Horizon West Transmission and Pacific Gas and Electric Company Estrella Substation and Paso Robles Reinforcement Project Proponent's Environmental Assessment (A.17-01-023)

Updated Response to Data Request No. 4

Exhibit 4-1.1b. Updated Figure 5: Updated LoadSEER Forecast, Paso Robles DPA

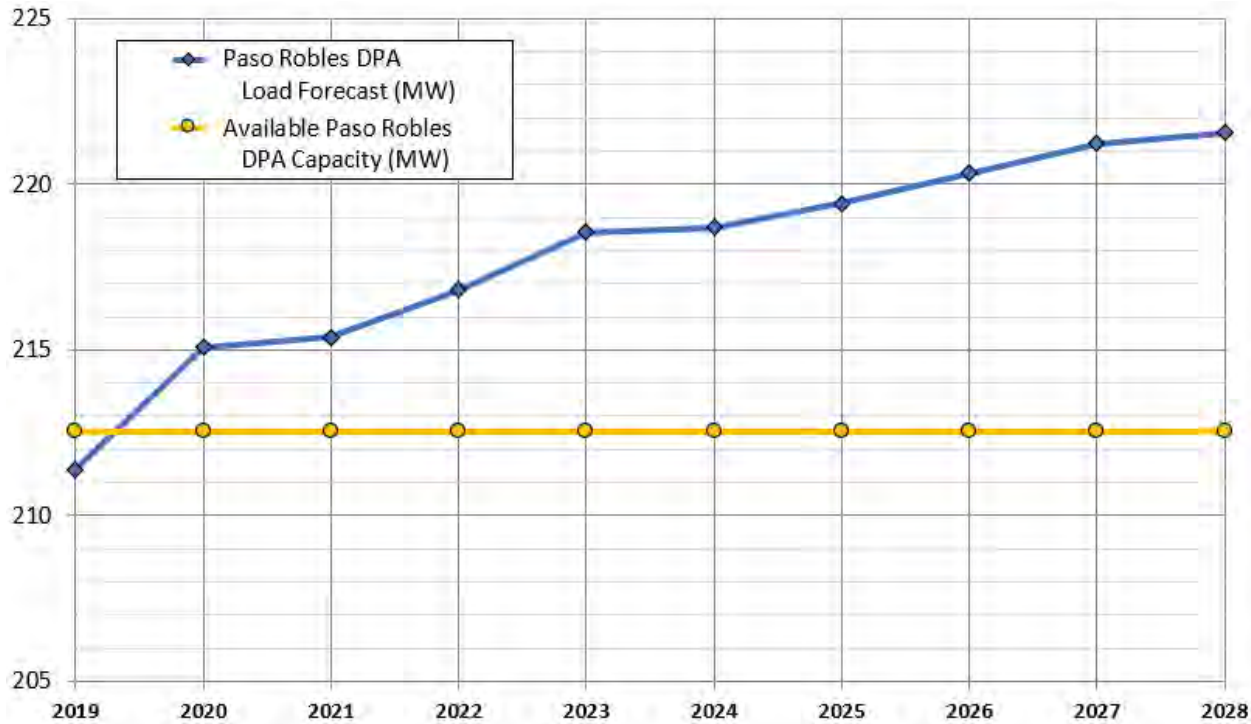
1. *Provide an updated load forecast for the Paso Robles DPA and update Appendix G to the Proponent's Environmental Assessment (PEA), as appropriate. At minimum, the following Appendix G tables and figures should be updated based on the 2018 recorded peak load and latest available Integrated Energy Policy Report (IEPR) data:*

- *Table 2. Historical Paso Robles DPA Capacity and Load*
- *Figure 5. Updated LoadSEER Forecast, Paso Robles DPA*
- *Table 3. Breakdown of Updated LoadSEER Forecast*
- *Table 4. Breakdown of Substation Capacities and Forecasted Loads, Paso Robles DPA*
- *Figure 6. Comparison of LoadSEER Forecasts, Paso Robles DPA*
- *Table 5. Previous 1-in-10 LoadSEER Forecast Incorporating Varying Percentages of the DER Forecast*

Previous LoadSEER forecasts projected that total load within the Paso Robles Distribution Planning Area (DPA) would exceed available capacity in 2024. The 2017 LoadSEER forecast presented in the May 2017 version of Appendix G projected an overload at the DPA level, and only one overload at the substation bank level. The subsequent 2018 LoadSEER forecast presented in the June 2018 version of Appendix G projected numerous bank and circuit level overloads, influenced by renewed residential and commercial growth within the DPA, coupled with 2017 load data resulting from a 1-in-10 peak temperature heat wave. The current LoadSEER 2019 forecast continues to project overloads at individual substation transformer bank levels, as shown in Exhibit 4-1.1d (New Table 4b). This should be contrasted with the 2017 LoadSEER forecast which only projected the one substation bank overload. Also of note is that all three forecasts have shown the need for a capacity increase in Paso Robles DPA, initially projected in 2024, and now accelerated up to 2020, when assessed at the DPA level.

While Exhibits 4-1.1a through 4-1.1f are provided as updated figures and tables per Request #4-1, Appendix G will be revised to reflect updated peak loads and growth information for the Paso Robles DPA. A revised version of Appendix G will be provided at a later date.

Exhibit 4-5. Transition Station Examples

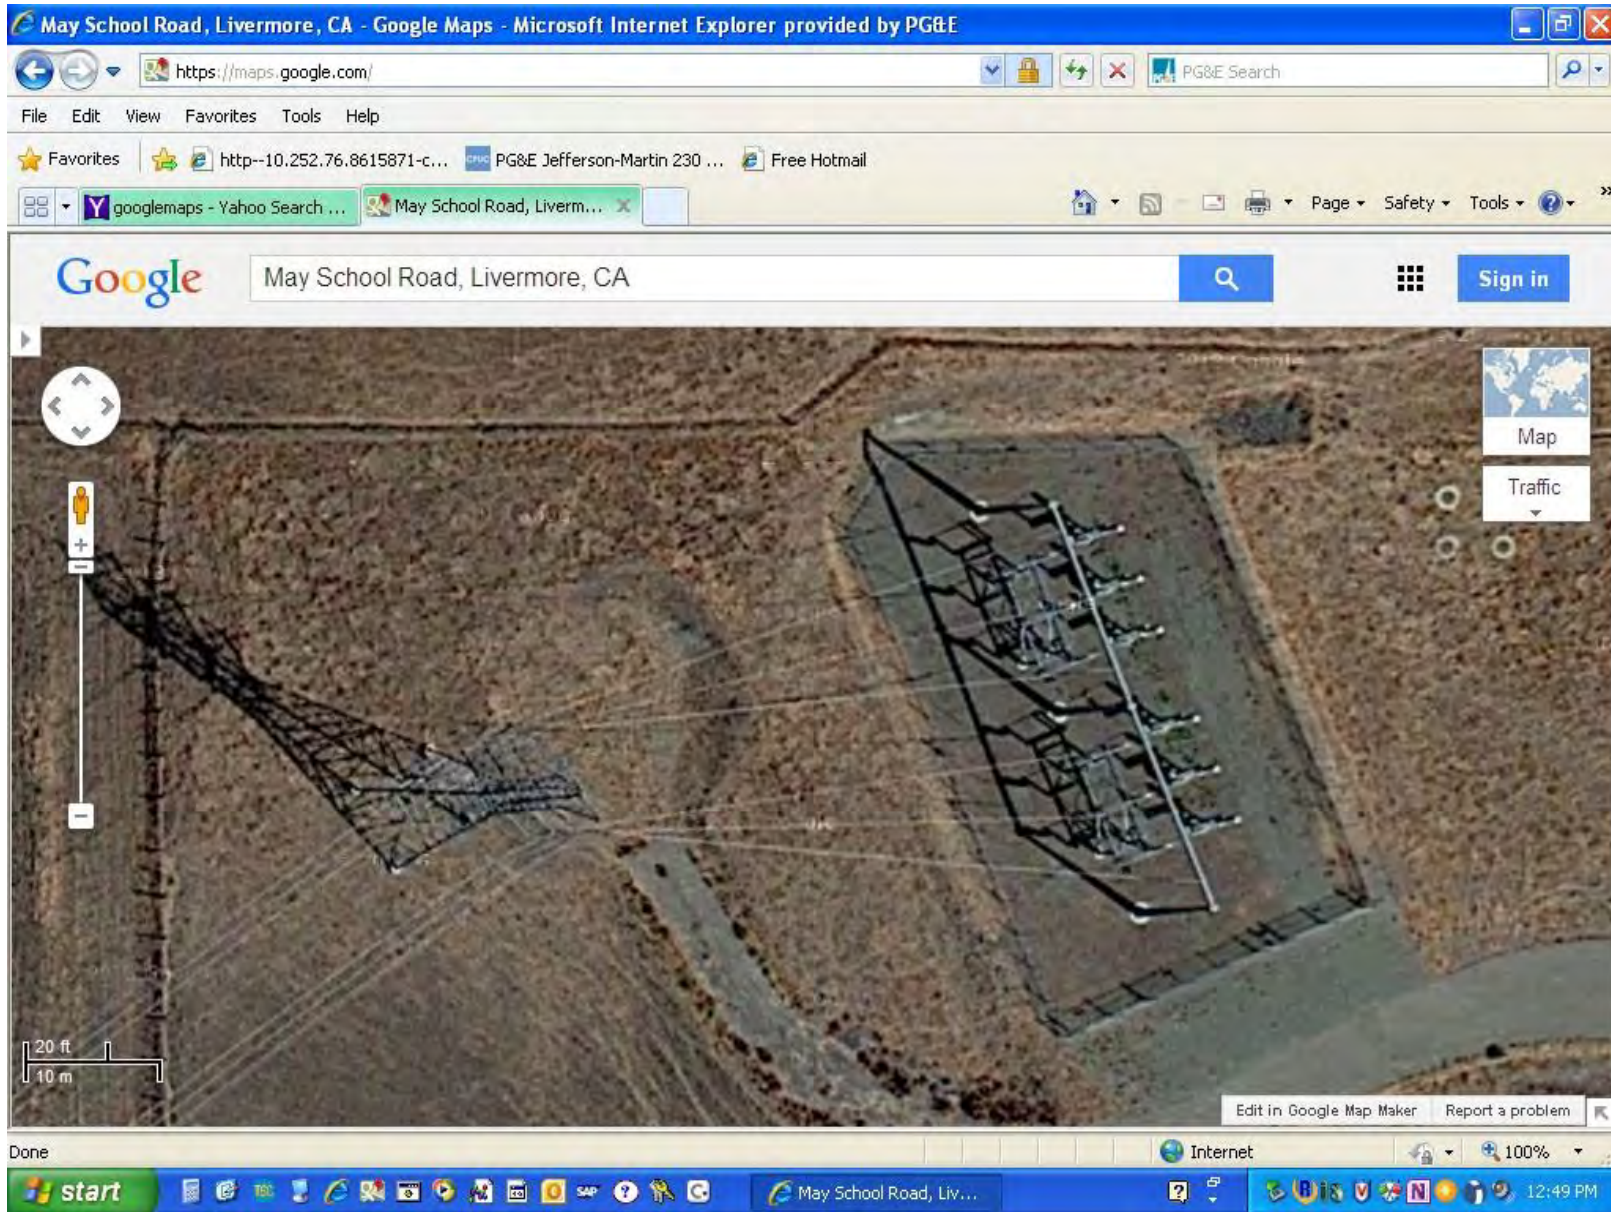
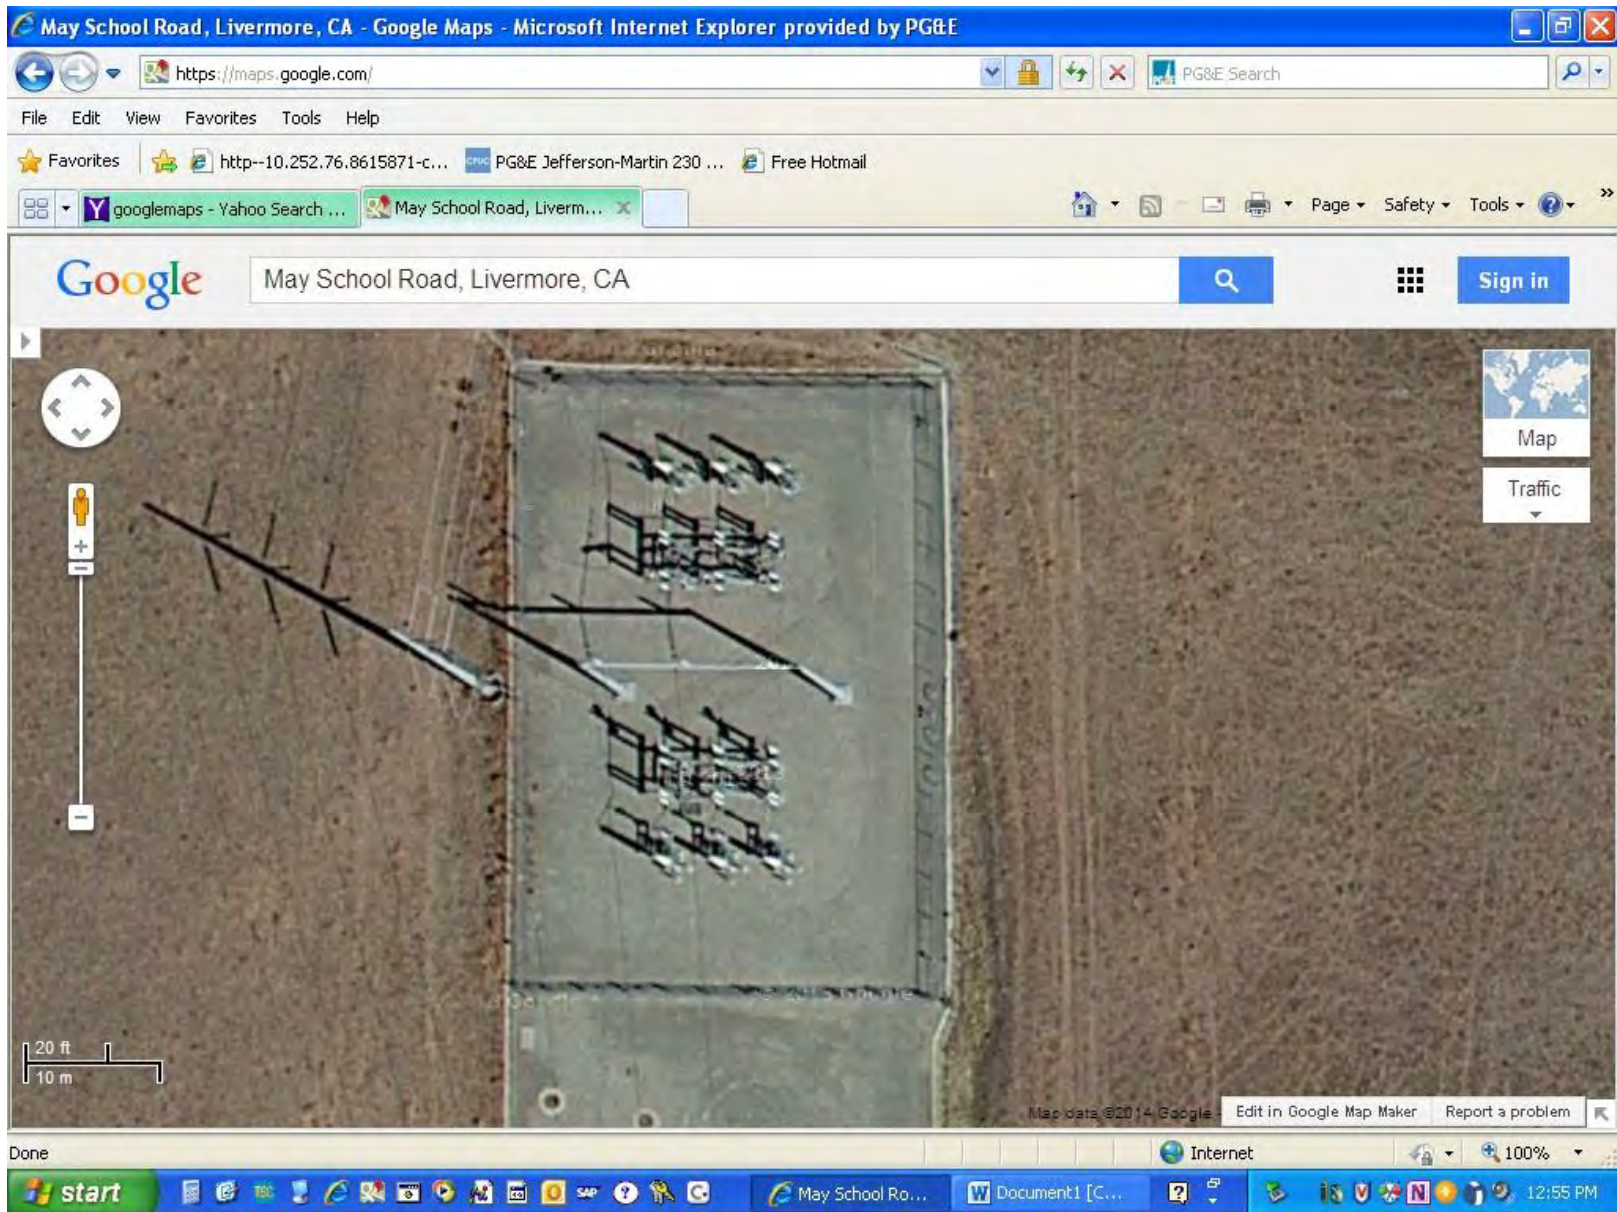
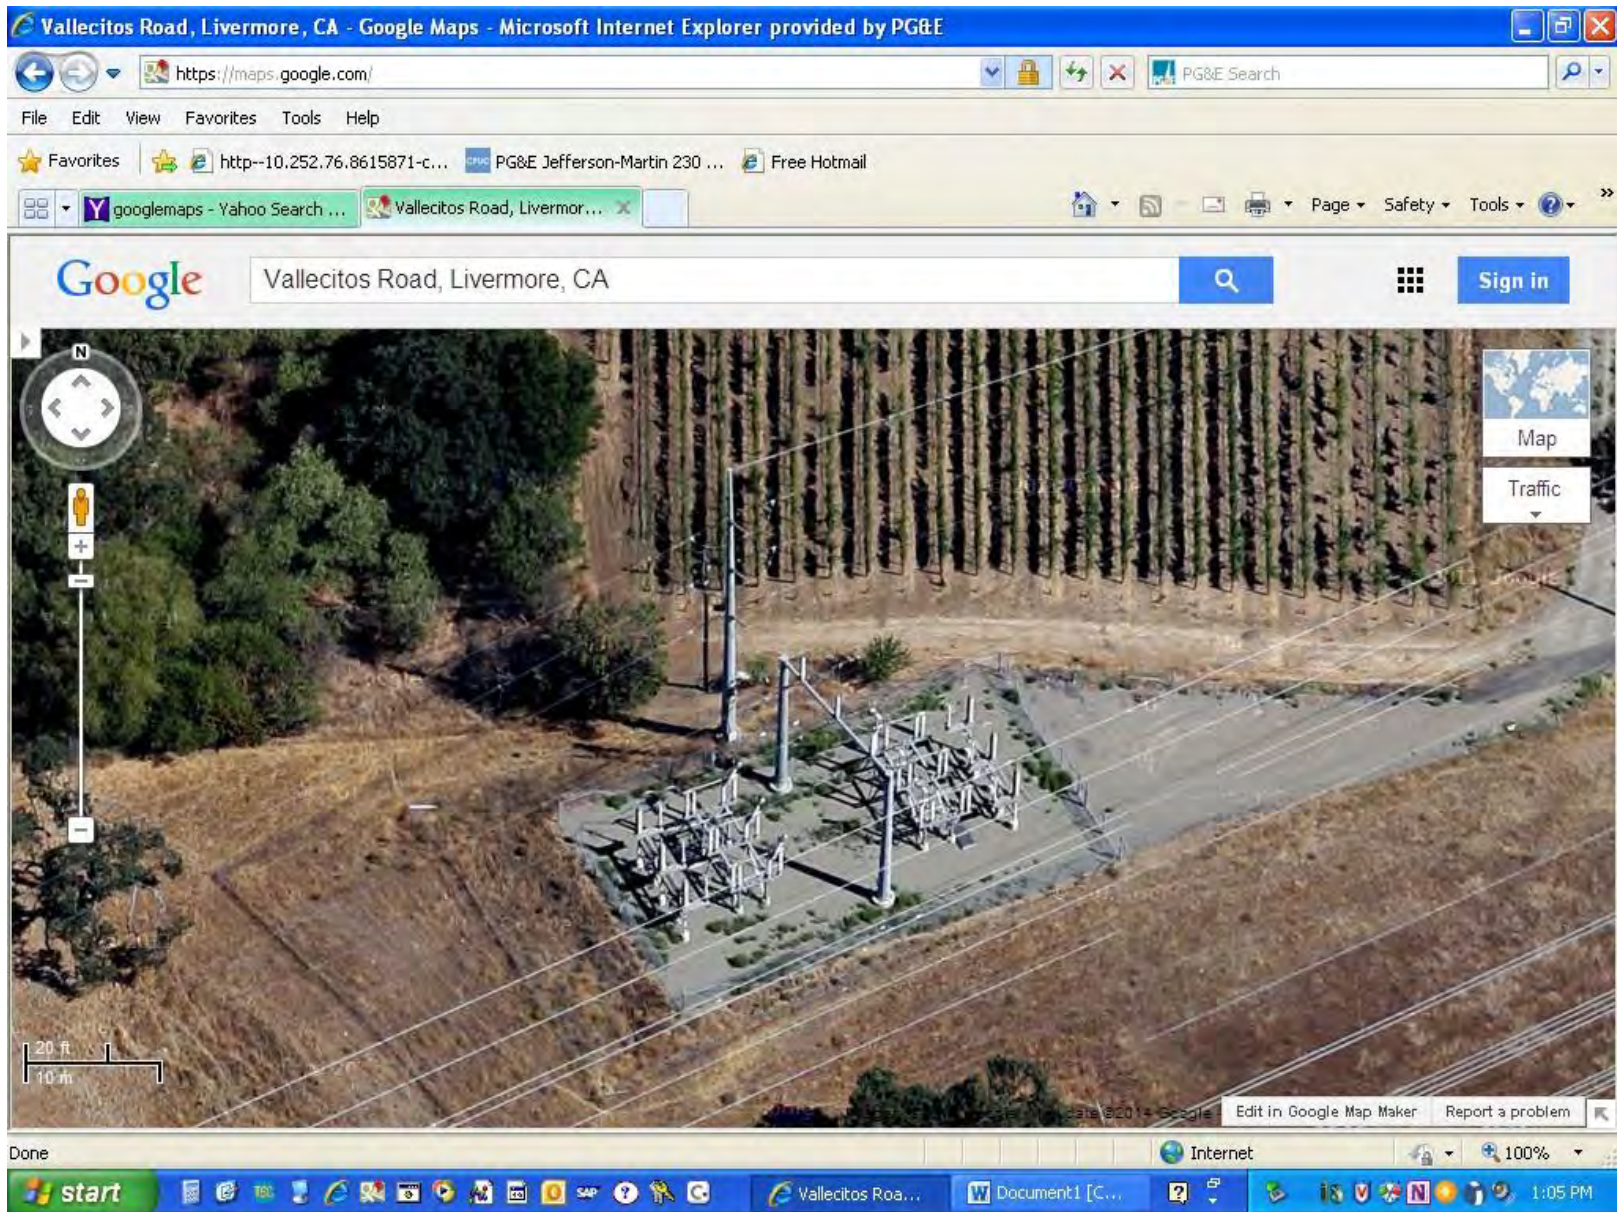
2. *Please clarify the need for facilities at the beginning and end of the underground alignment. Will it be a riser pole or something more? If something more, explain why and provide examples of similar installations that require something akin to a, "small substation," rather than simply an entrance and exit point from the underground conduit (e.g., via the typical riser pole design footprint). Explain the specific conditions under which the additional facilities would be necessary and whether they are for something already planned pursuant to an adopted planning document or for something that might occur in the future.*

2. Two riser poles would be constructed at each end of the underground alignment. In addition, a transition station may also be constructed at each end of the underground alignment. Transition stations may be required because current on each conductor has to be continuously monitored in case there is an electrical fault in the underground section. By monitoring the current coming into and leaving the underground section, any differential in the current would trip the substation relays/circuit breakers feeding both ends of the transmission line. If the electrical current differential relays trip, it can be determined that the fault is in the underground section of the line and not the overhead portion of the circuit. Without the transition stations and their electrical current differential sensing, the underground section of line would need to remain de-energized after any circuit fault and be patrolled and inspected by an underground specialist prior to re-energizing. This means the entire circuit would remain de-energized until the underground section can be patrolled and inspected and cleared for re-enerization. All PG&E underground specialists are located in the San Francisco Bay area, and it can take days in some cases before they are available to inspect circuits in remote areas. Transition stations would provide for faster circuit restoration after an electrical fault. Examples of similar transition stations are provided in Exhibit 4-5. PG&E does not have a planning standard

for transition stations; however, based on discussions with PG&E's operations, protection, planning, and asset strategy groups, a planning standard for transition stations may be developed in the future. Therefore, PG&E is proposing to include transition stations for the underground options as a conservative approach for engineering design and environmental analysis.
